**METROPOLITAN GOVERNMENT OF NASHVILLE AND DAVIDSON COUNTY**

**STAFF RECOMMENDATION**  
**505 Buchanan Street**  
**August 15, 2018**

**Application:** New Construction—Infill  
**District:** Salemtown Neighborhood Conservation Zoning Overlay  
**Council District:** 19  
**Map and Parcel Number:** 08108046600  
**Applicant:** Axis Creative, LLC; Will Jenner, Designer  
**Project Lead:** Sean Alexander, sean.alexander@nashville.gov

**Description of Project:** A proposal to construct a new two story house on a vacant lot. The house will be thirty-three feet (33') tall and thirty-four feet (34') wide. It will be clad with brick with a stone foundation and an asphalt shingle roof.

SITE PLAN

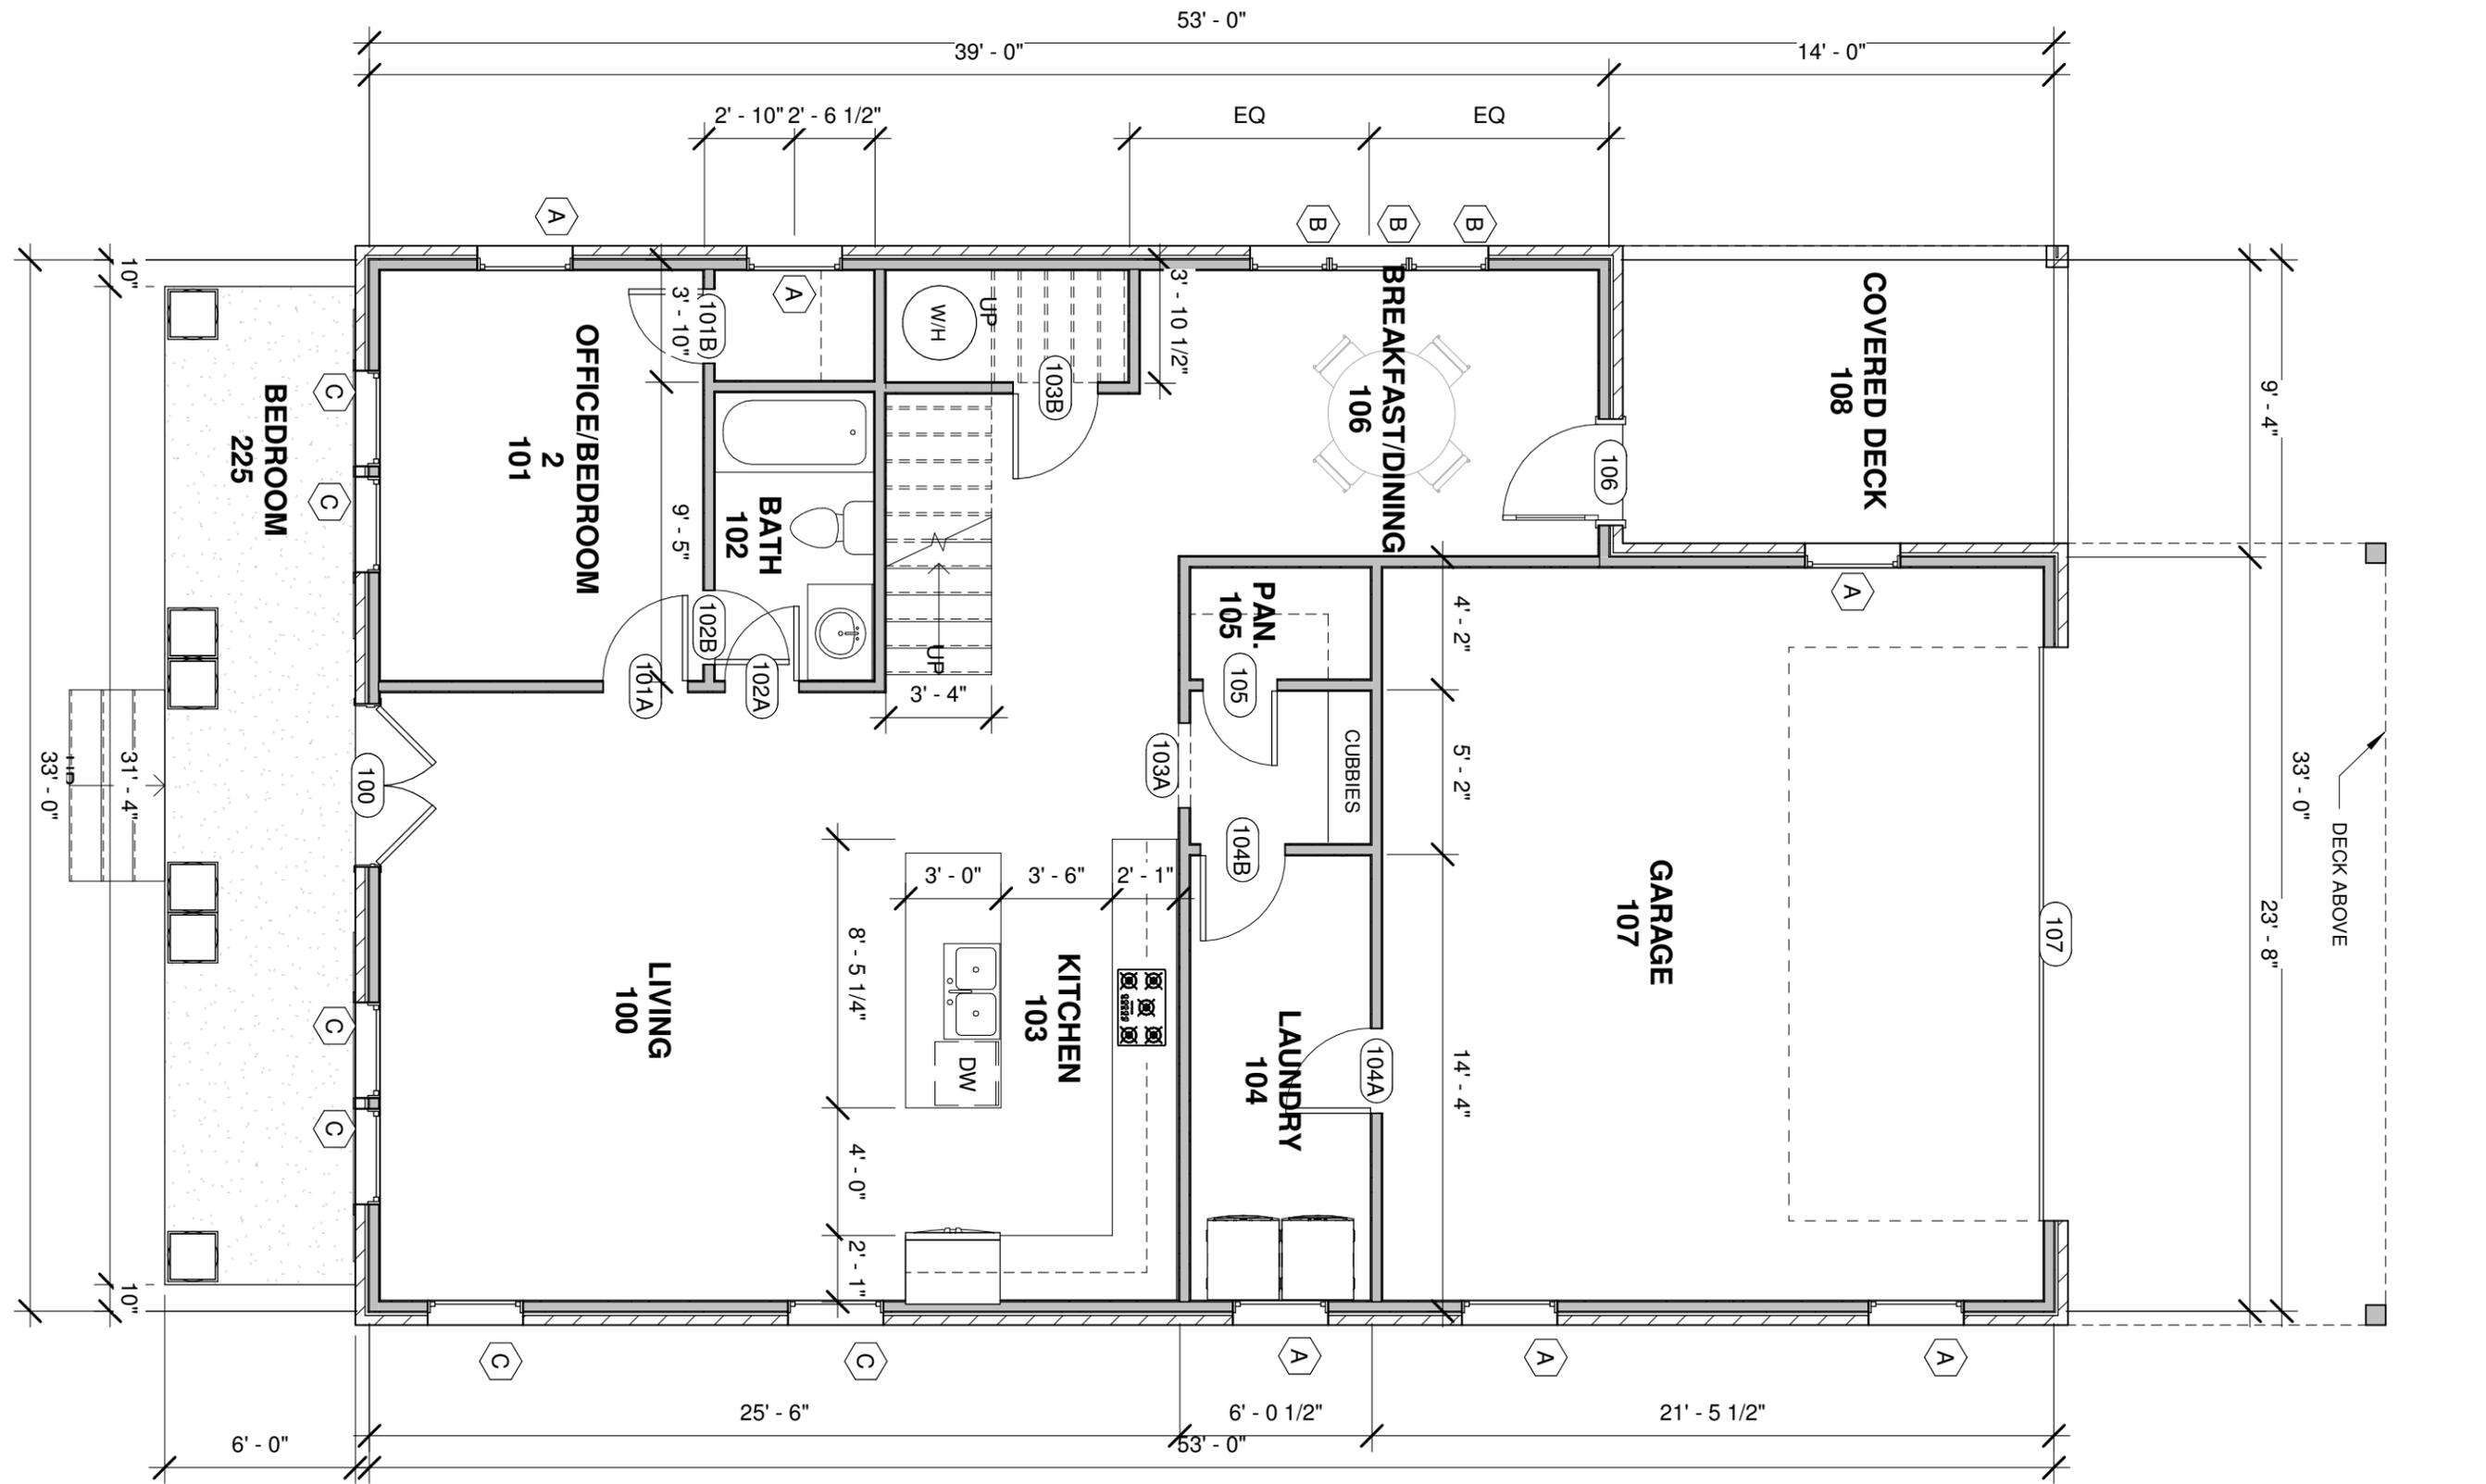
**Setback & Rhythm of Spacing:** The new building will be five feet (5') from the side property lines and twenty feet (20') from the rear property line. The front setback is seventeen feet, eight inches (17'-8"). This is slightly forward of the non-contributing building two lots to the right, but matches the front setback of the nearest contributing building on this block and the recently approved infill to the left. Staff finds that the proposed infill meets Section III.C of the design guidelines, with a recommended condition that the appropriate front setback shall be verified on site before construction begins.

Orientation: The new building will be oriented with the primary façade facing Buchanan Street directly, as is typical of historic houses nearby. The site plan indicates that there will be a walkway added in the front yard connecting the front porch to the sidewalk and a driveway in the rear to access an attached garage. As with approved infill on the adjacent lot, Staff finds that an attached rear-facing garage on the main first-floor level is appropriate because the lot is very shallow at only ninety-nine feet (99') deep whereas the standard lot in the district is one hundred seventy feet (170') on average. Because the garage faces the rear and is alley accessed, it will not be visible. Staff finds that the project will meet section III.F of the design guidelines.

1. The front setback shall be consistent with setbacks of the adjacent historic houses, to be verified by MHZC staff in the field;
2. The finished floor height shall be consistent with the finished floor heights of nearby historic houses, relative to natural grade, to be verified by MHZC staff in the field;
3. A window opening shall be added on the right side on the upperstory, toward the front;
4. Brick and stone samples shall be approved by MHZC Staff;
5. The window and door selections shall be approved by MHZC Staff;
6. The roof color shall be approved by MHZC Staff;
7. The material of the front walkway and rear driveway shall be approved by MHZC Staff; and,
8. The utility connections and HVAC units shall be located behind the midpoint of the building on a non-street facing façade.

RIGHT ELEVATION

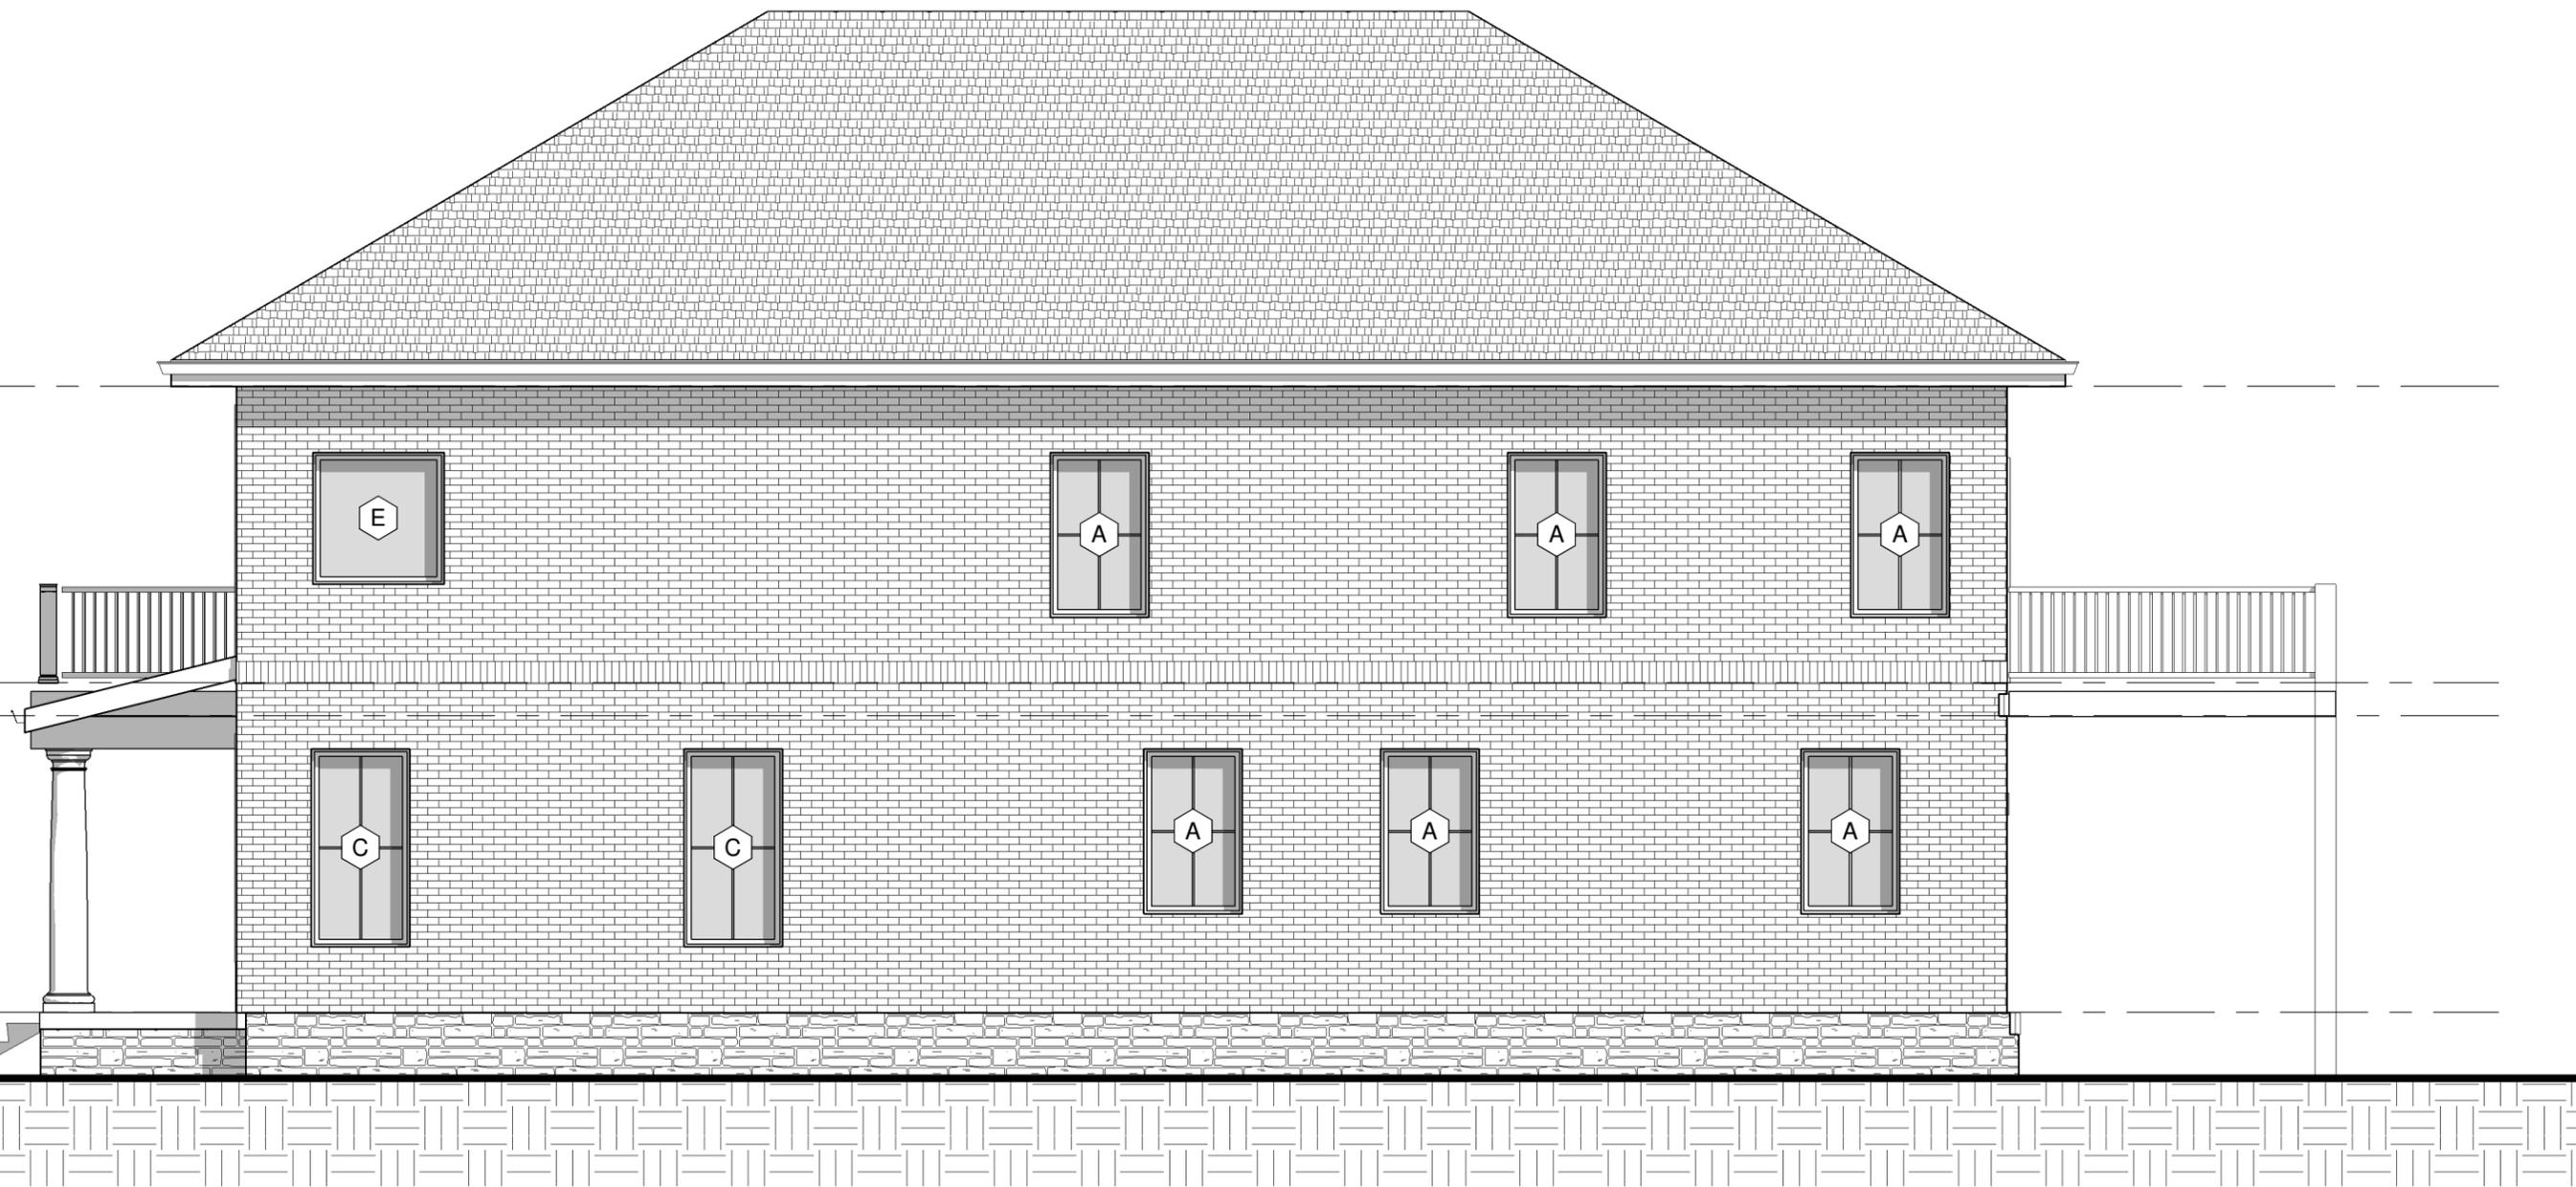
Proportion and Rhythm of Openings: The windows are generally twice as tall as they are wide, as is typical of the proportions of openings on historic buildings nearby. The pattern of window placement is also compatible with nearby historic buildings, with the exception of a section of wall on the right side of the building's upperstory. This space, which is toward the front of the building, has an expanse of nineteen feet (19') without an opening. Staff recommends adding a window or windows in this area to break up the uninterrupted wall area, as historic houses nearby typically do not have any expanse of wall greater than twelve feet (12') without an opening. With this condition Staff finds that the proposed infill will meet section III.G of the design guidelines.
